EASA	COMMENT RESPONSE DOCUMENT
	<p align="center">EASA PAD No. 12-098 [Published on 31 July 2012 and officially closed for comments on 21 August 2012]</p>

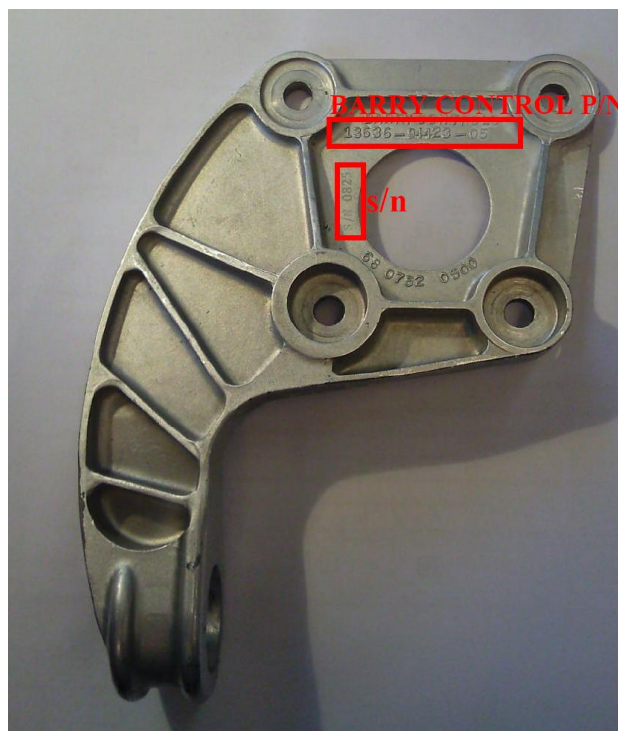
Can you please also advise where on the Ref/B/ fitting the Serial Number is engraved to ease its localization?

The picture below highlights the areas where the fitting data quoted through the PAD can be found. This picture is also reproduced in the Final AD.
